PARKING RAMP - SOUTHEAST VIEW

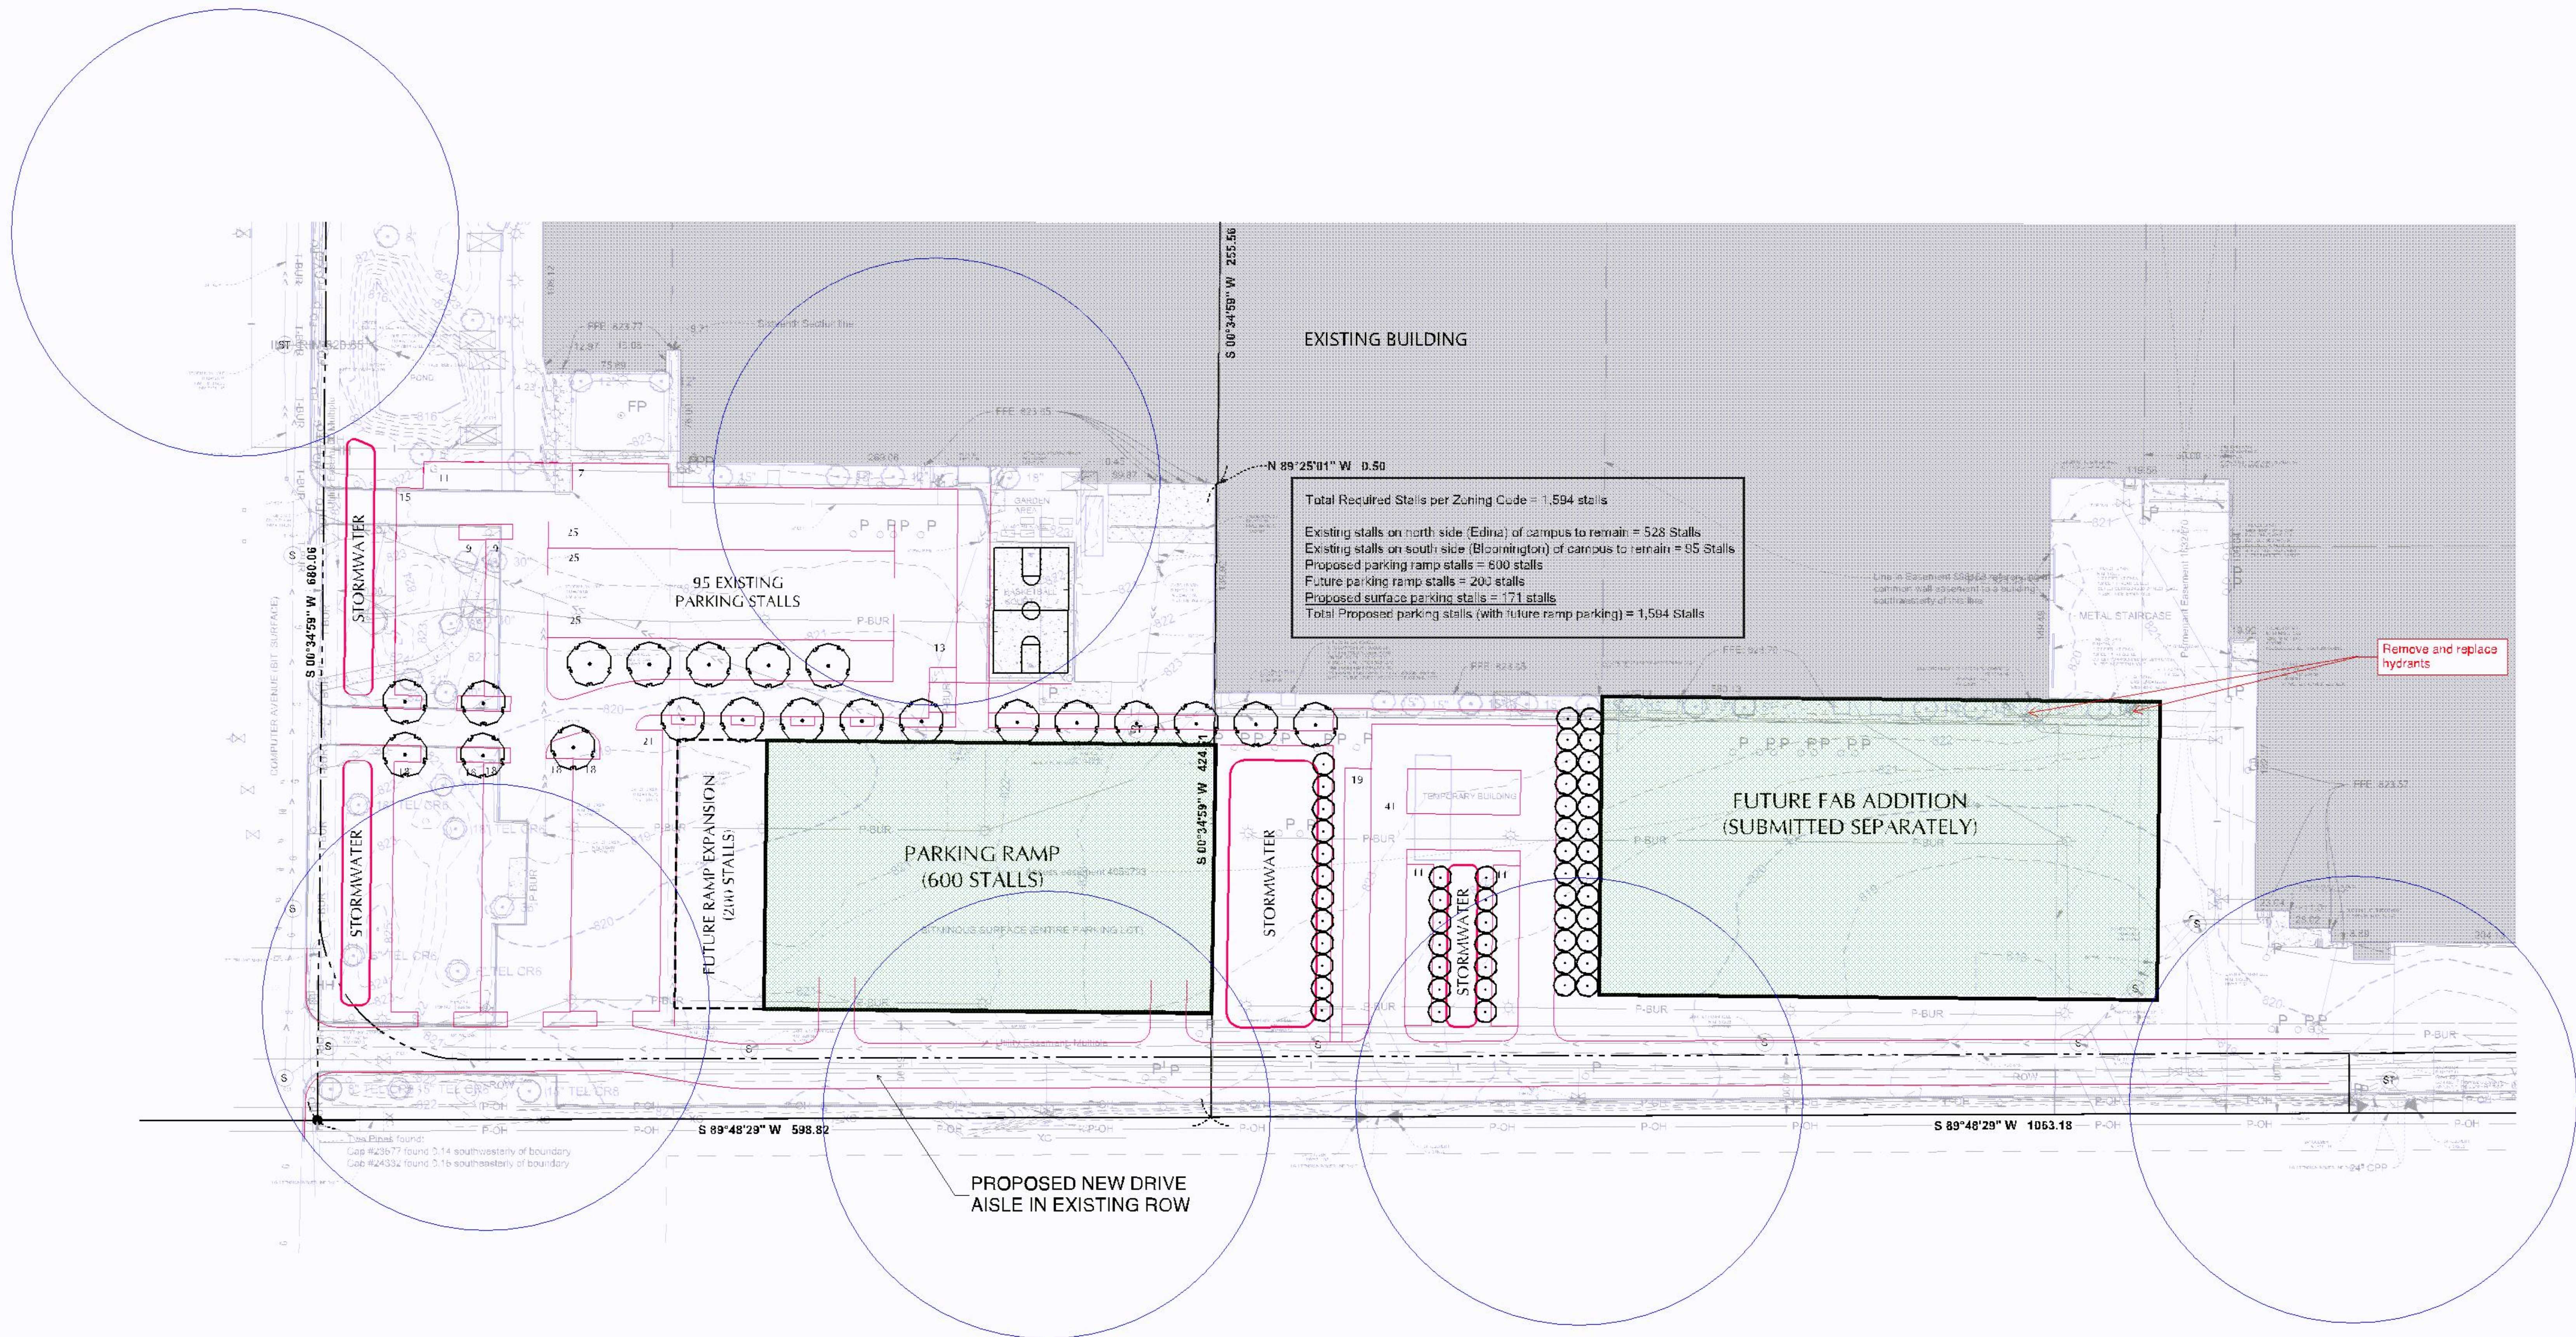
Must meet 2020 MN State Building Code

Provide a code analysis with the plans.

Must meet 2020 MN Accessibility Code

PARKING RAMP - NORTHEAST VIEW

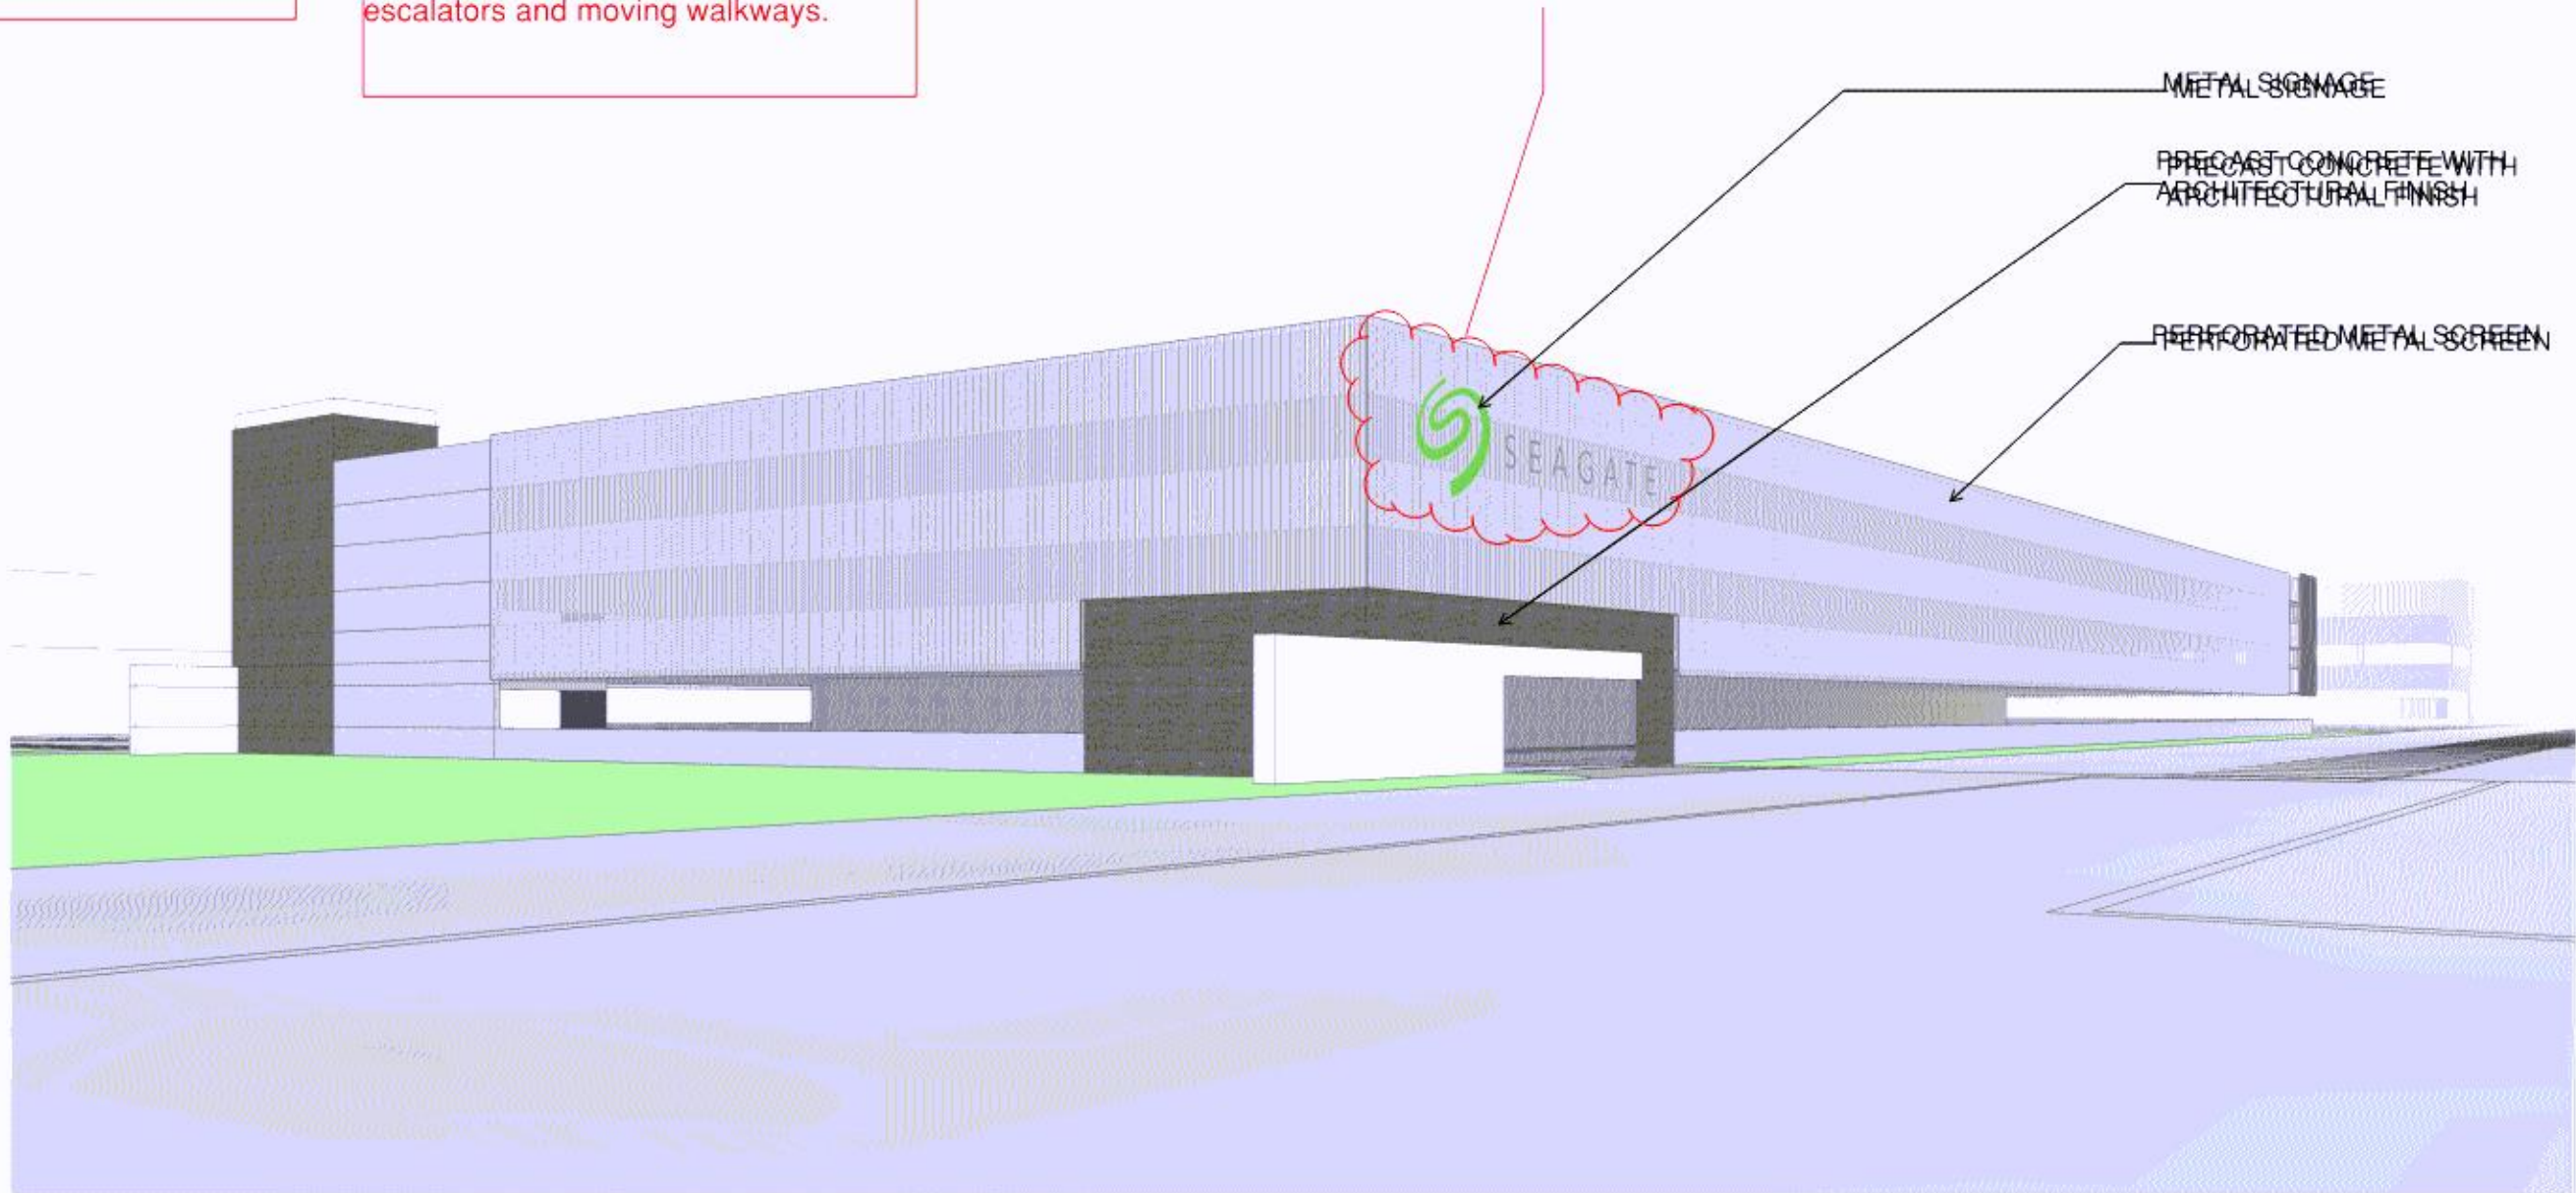
The City Code does not allow business signs on a parking ramp. Signs must be on the wall of the occupied building or freestanding, as allowed.
